Service Letter: No. 349

Subject: Inspection of the Bell 407 Air Conditioner Driveshaft Mounted Pulley and Drive Ring Assembly.

Applicability: Bell Helicopter Model 407 Equipped with the Air Comm Air Conditioning system, Serial Numbers AC407-80 and subsequent.

S-3532EC-4 Pulley & S-3532EC-5 Drive Ring Installation (-3 Installation)

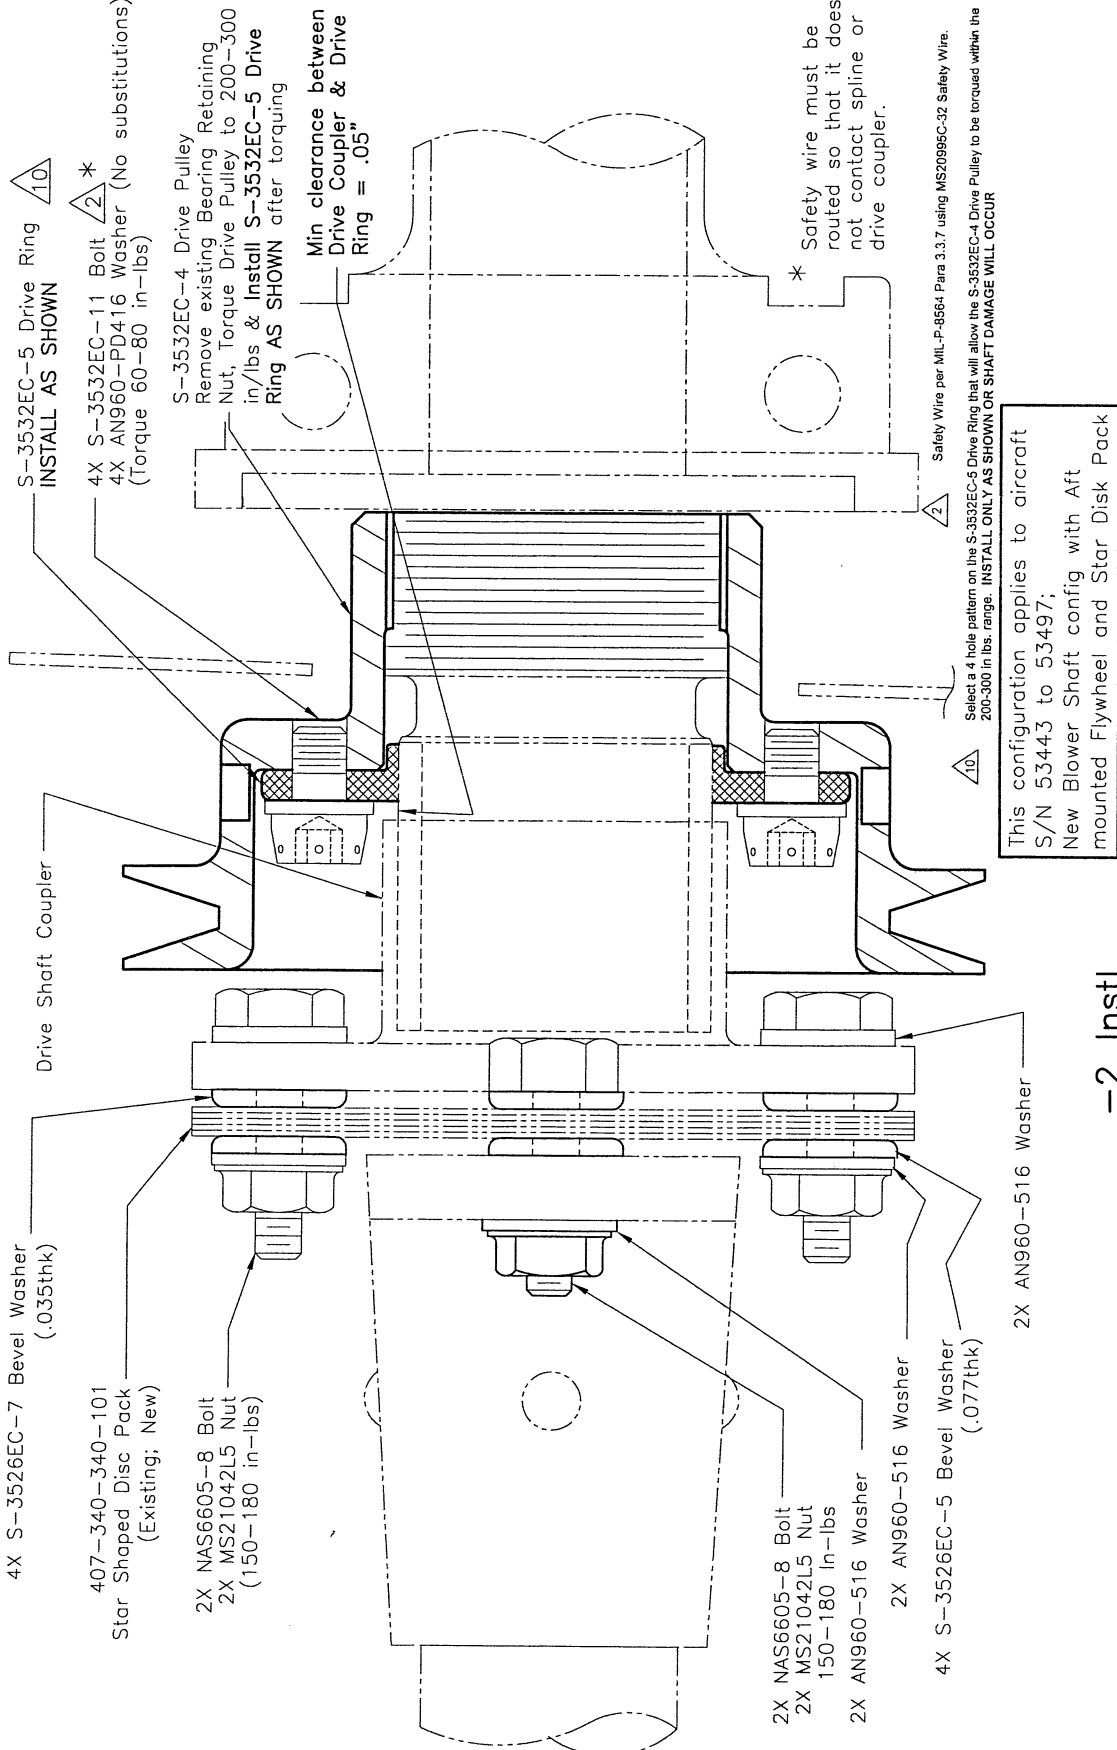
We highly recommend that all operators inspect the installation of the S-3532EC-4 Pulley & S-3532EC-5 Drive Ring assembly on helicopters equipped with the Air Comm Corporation air conditioning system, to insure that the S-3532EC-5 Drive Ring is installed as shown on Pages 2 thru 5 of this Service Letter. **The splined leg of the Drive Ring must be oriented aft to insure the .05 inch clearance with the drive shaft coupler.**
